TOWN OF NORTH CASTLE
WESTCHESTER COUNTY
17 Bedford Road
Armonk, New York 10504-1898

PLANNING DEPARTMENT
Adam R. Kaufman, AICP
Director of Planning

Subject: **Praise Church – 901 North Broadway – Special Use Permit and Site Plan Approvals [2022-039]**

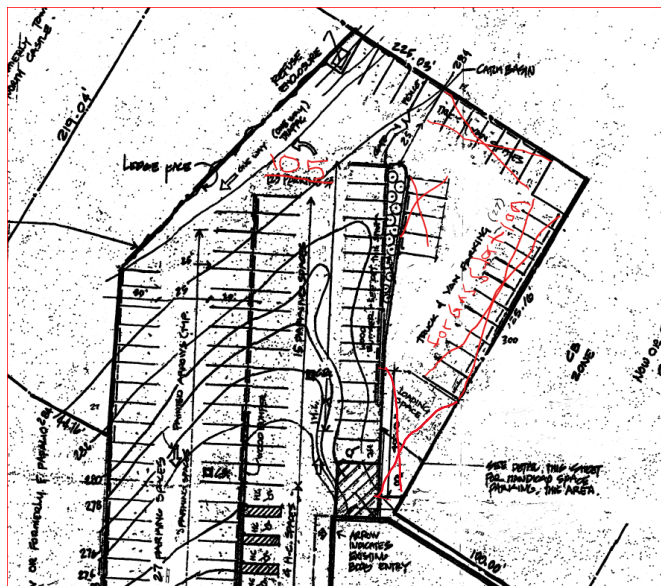
4. The site plan should be revised as depicted below:
